# UNITED STATES PATENT AND TRADEMARK OFFICE

APPLICATION NO.	FILING DATE	FIRST NAMED INVENTOR	ATTORNEY DOCKET NO.	CONFIRMATION NO.
09/652,927	08/31/2000	Theodore W. Meyers		4367

# Office Action Summary

### DETAILED ACTION

Attachment # 1

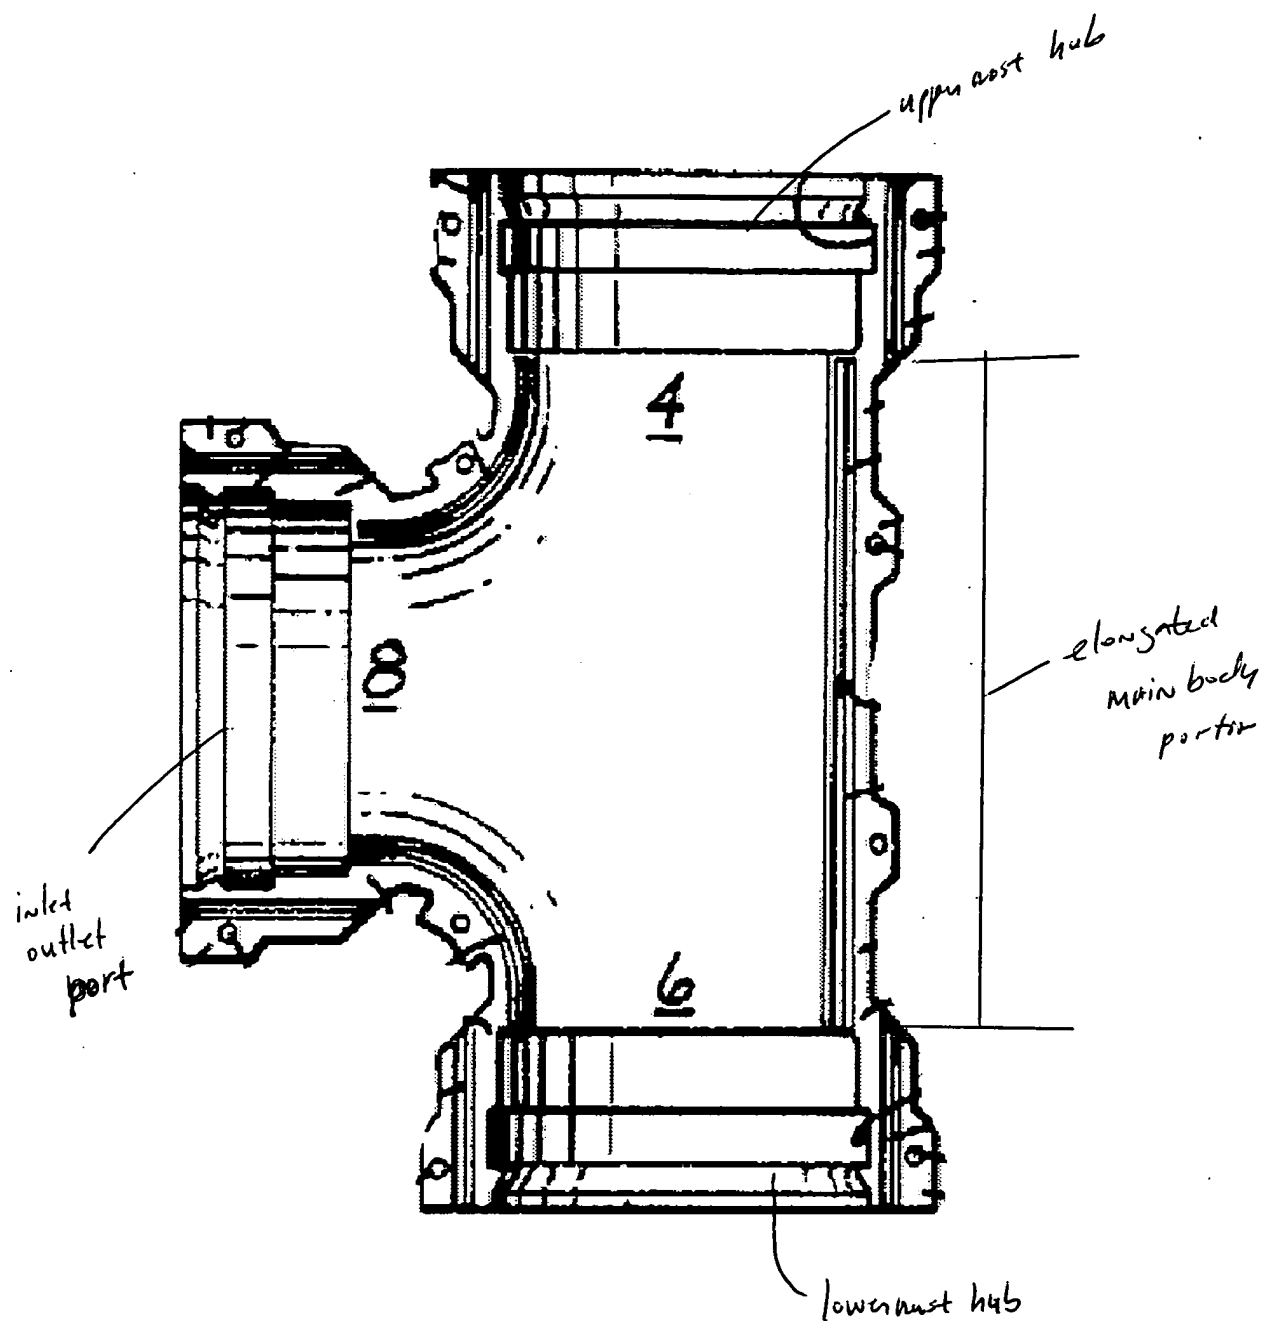
Regarding claim 1, Morrison discloses a tee (16) comprising a cylindrical main body portion (a, see attachment #1) defining a tubular opening adapted to receive a filter.

A cylindrical uppermost hub (above where a<sup>5</sup> is pointing in Figure 7, see attachment #1) is coaxially with the cylindrical main body portion. The uppermost hub includes an inner diameter greater than the diameter of the cylindrical main body portion.

An inlet/outlet port (a<sup>3</sup>) is in communication with the tubular opening. The inlet/outlet port includes an inlet/outlet hub (26), located at an open end of the port, having a diameter sized to receive a pipe. The diameter of the inlet/outlet hub is greater than the diameter of the cylindrical main body portion. The inlet/outlet port is adaptable to receive a pipe (Figure 1).
